**ADA TOWNSHIP PLANNING COMMISSION  
THURSDAY, AUGUST 20, 2020 MEETING, 7:00 PM**

**TO:** Ada Township Planning Commission  
**FROM:** Jim Ferro, Planning Director  
**RE:** PVM District Development Plan, Renovation and addition to existing office building and parking, 555 Ada Drive SE., Parcel No. 41-15-34-101-045, Erhardt Construction, on behalf of Orchard Hills Properties, LLC

**TO:** Ada Township Planning Commission  
**FROM:** Brent M. Bajdek, Planner/Zoning Administrator  
**RE:** August 20, 2020 Agenda Item – 3046 & 3050 Pettis Ave. NE  
(*New Business – Item #2*)

**Demolition Plan**

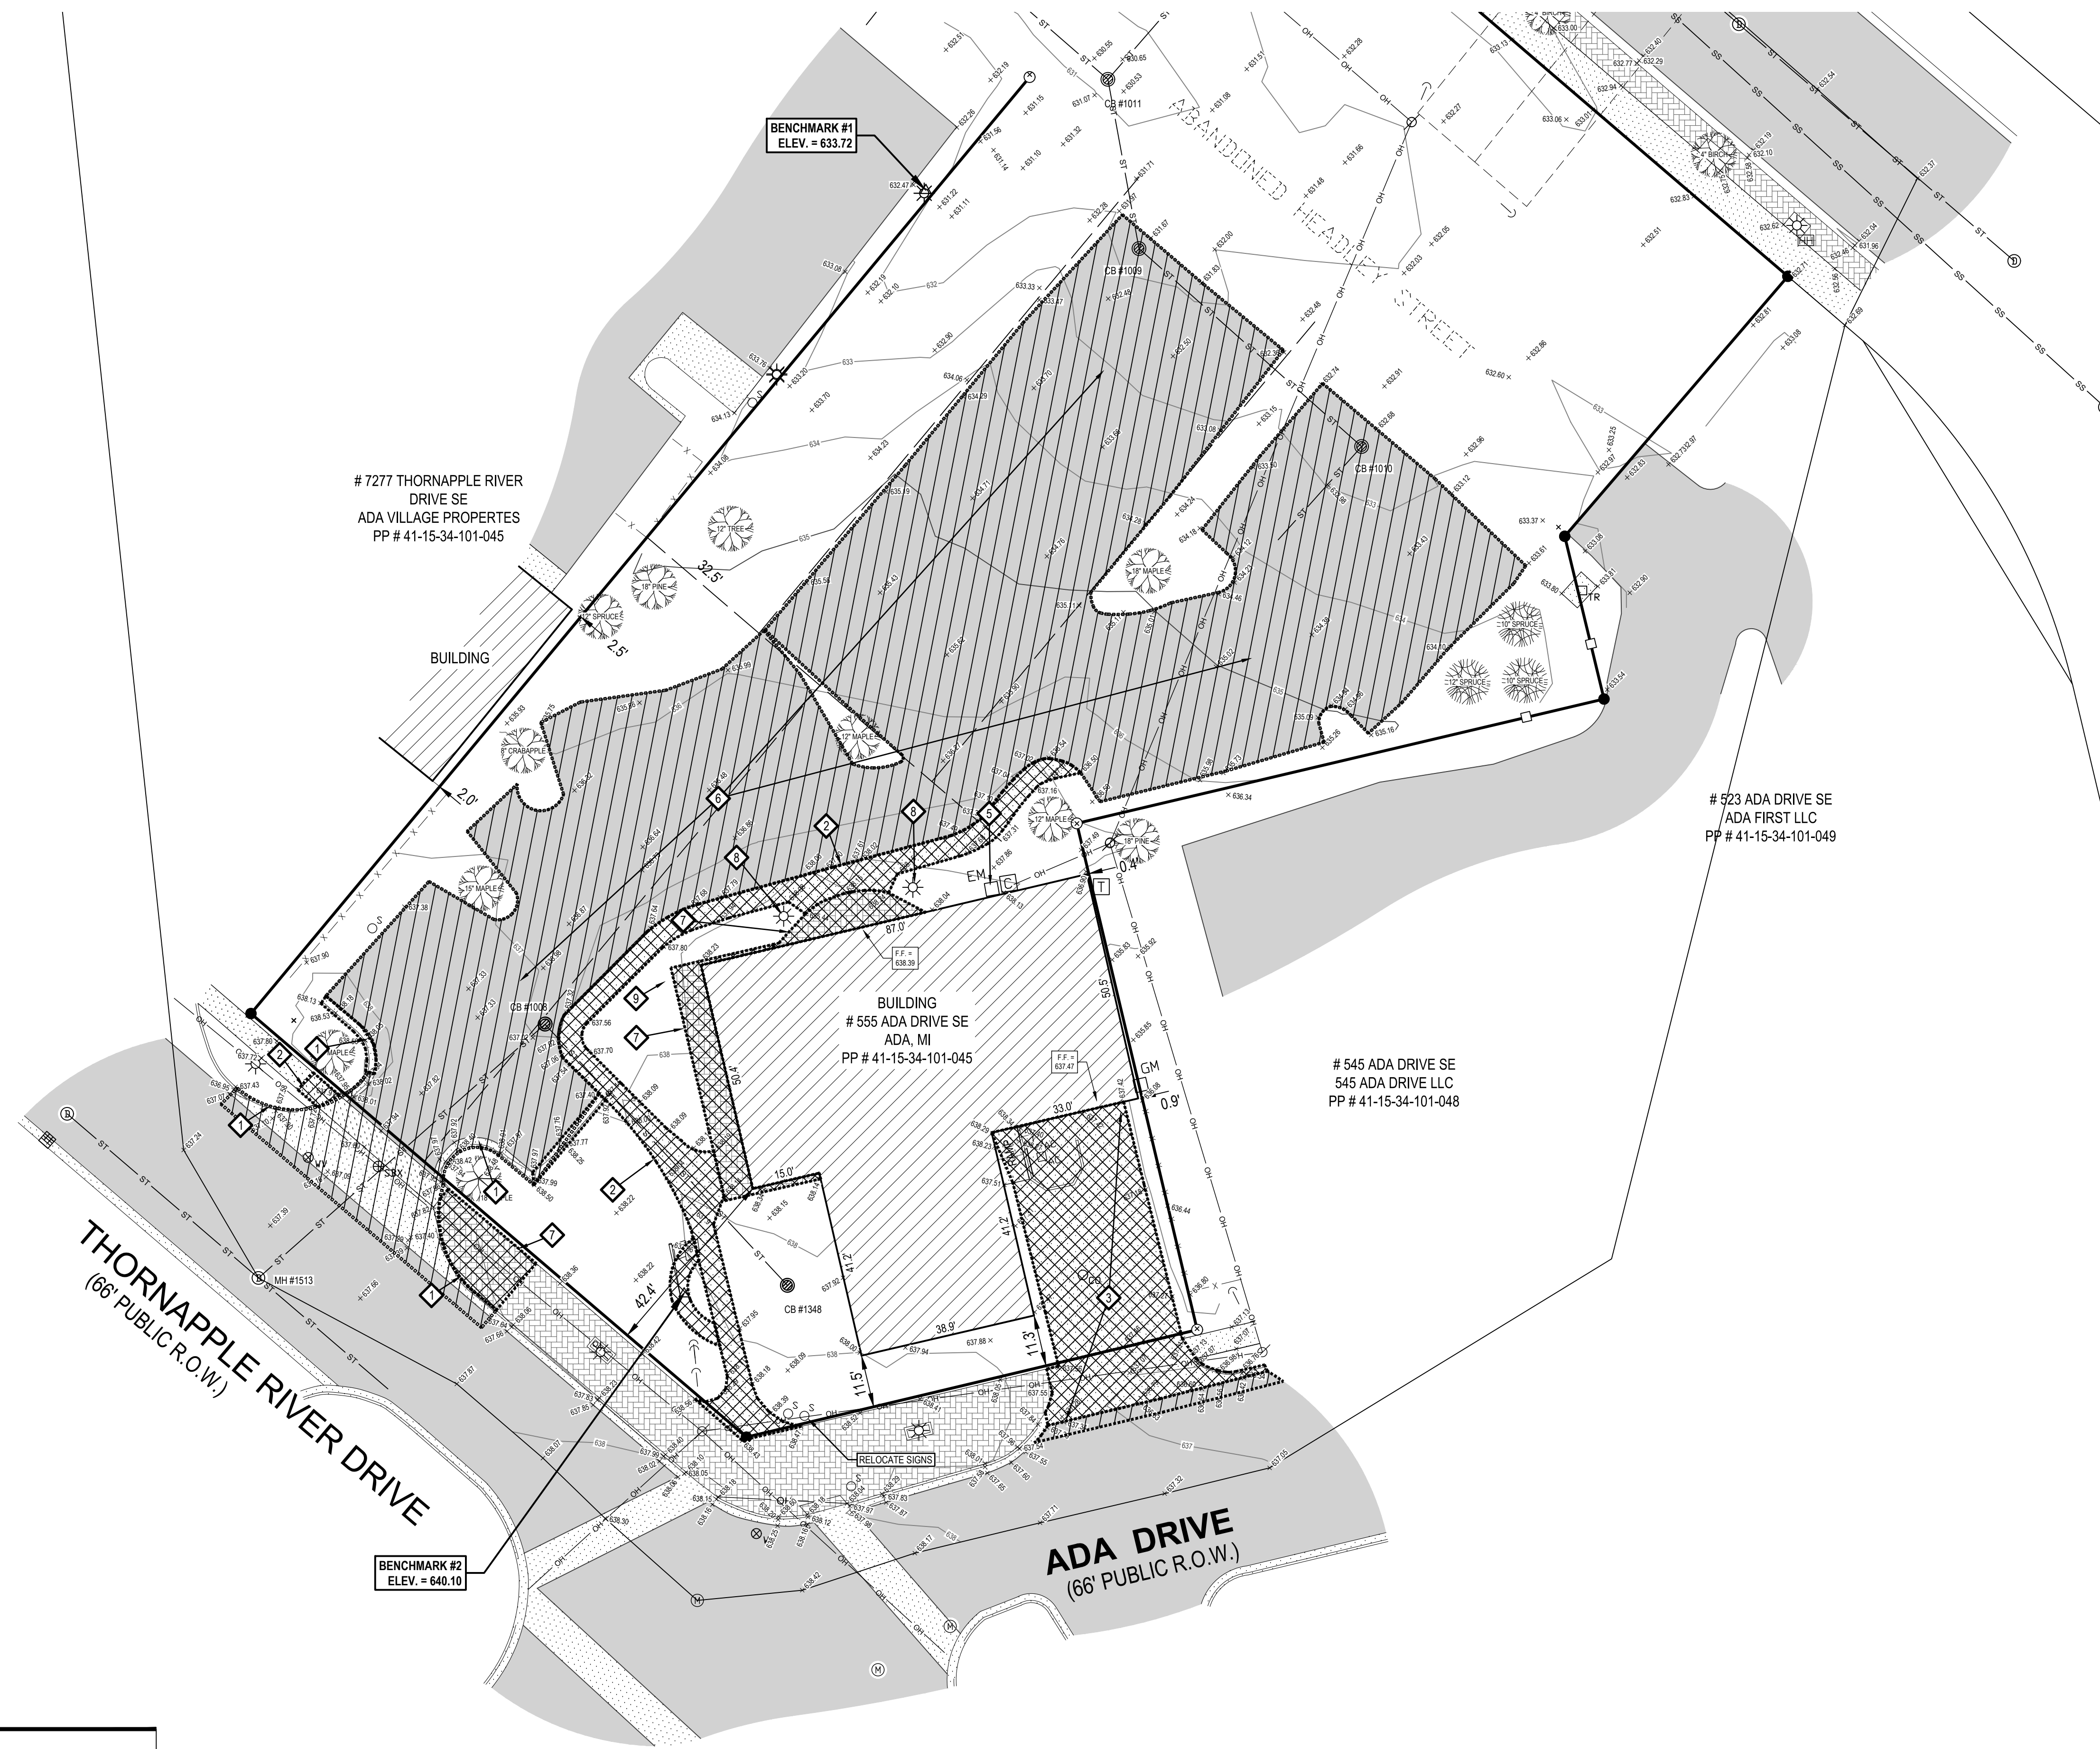
4. The demolition plan shall be modified to identify trees to be removed.
5. The landscape plan shall be revised to identify quantities, sizes and species of plant materials, for review and approval by Township staff prior to initiation of landscape improvements.

**Site Layout Plan**

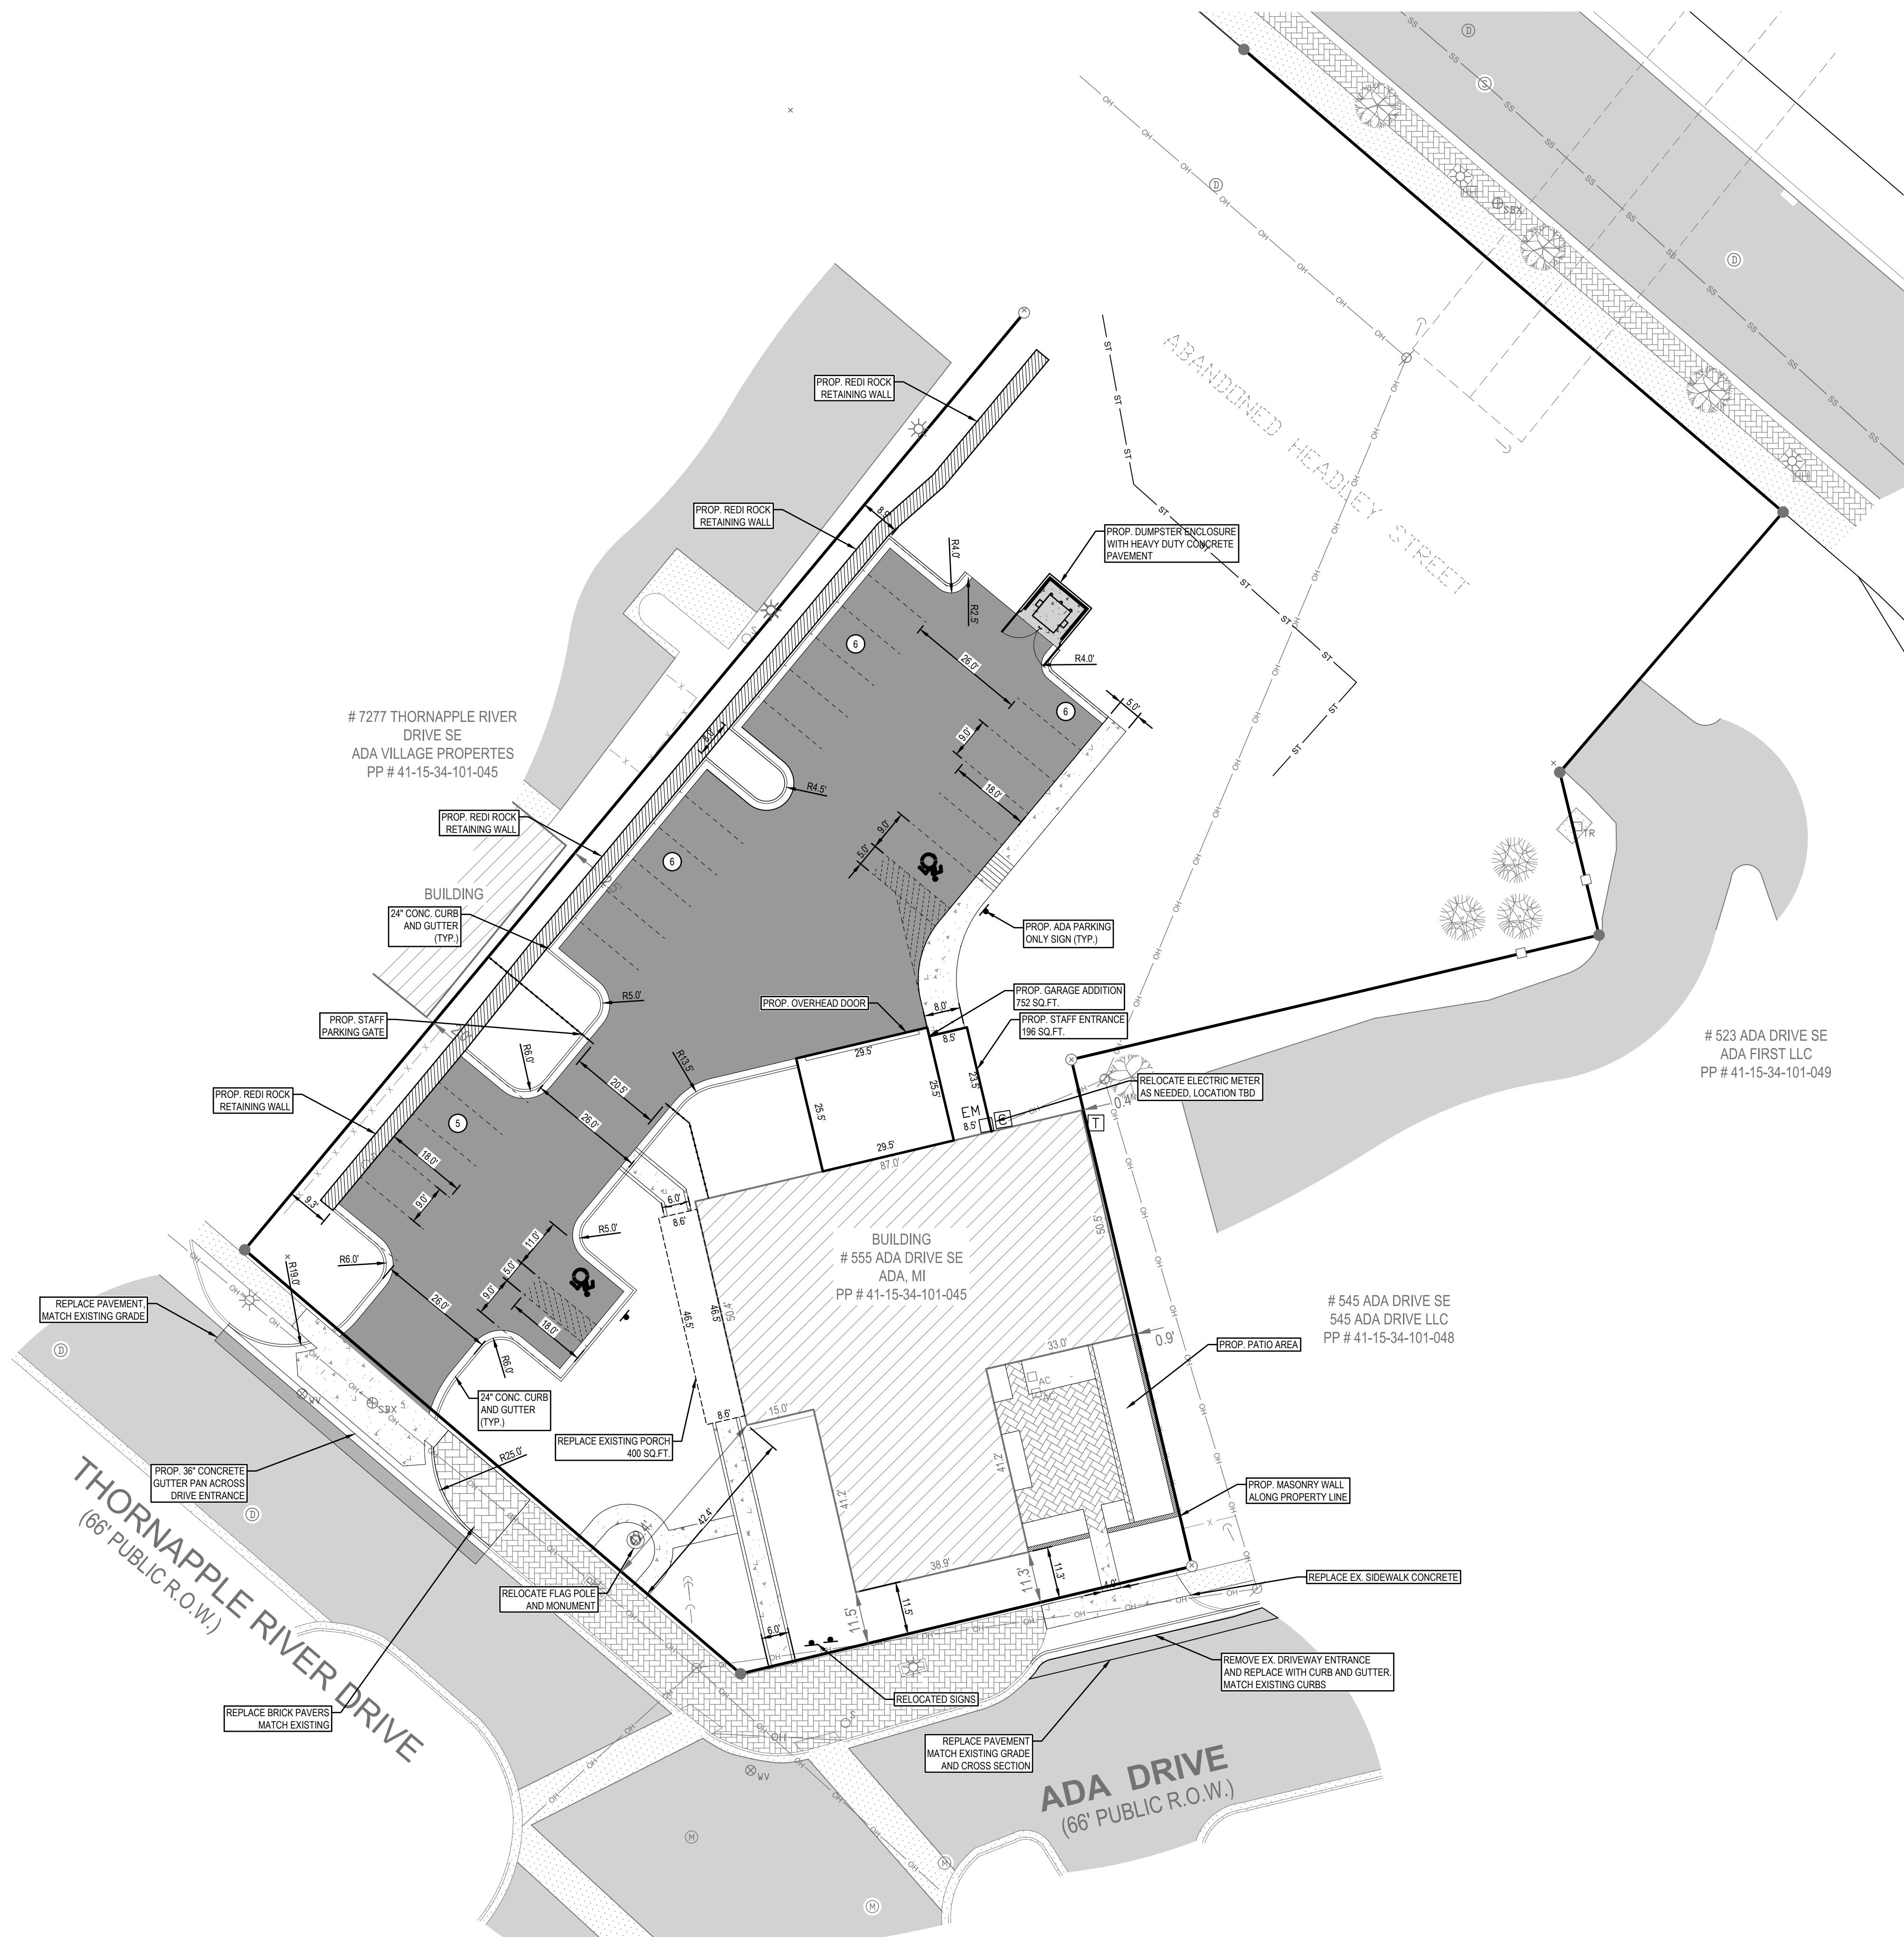
The parking area will continue to be accessed from Thornapple River Dr. The setback of parking from the Thornapple River Dr. right-of-way will be increased from 13 feet currently to 20 feet.

The total parking supply is 25 spaces, serving a total building size of 7338 square feet. Minimum parking required at a ratio of 1 space per 300 square feet is 24.46 spaces. The 7 parking spaces located closest to Ada Dr. are designated for visitor use, while the remaining 18 spaces are located behind an access gate and restricted to staff access only.

There are several existing good-sized maple trees located within or near the parking lot that are identified on the existing conditions plan. Based on the proposed parking layout, it appears that 2 of the 4 existing maple trees will need to be removed. (The demolition plan does not identify trees to be removed). It appears that one of these trees, located just south of a large proposed island along the west edge of the parking area, could be retained if the location of the island is shifted slightly to the south. The possibility of making this adjustment should be evaluated.

A note on the site plan indicates “all lighting shall be shielded from all adjacent properties,” and that “proposed lighting shall consist of wall-mounted lights and light poles, both fitted with ‘shoebox’ type fixtures.”

A fixture specification should be submitted prior to building permit issuance.
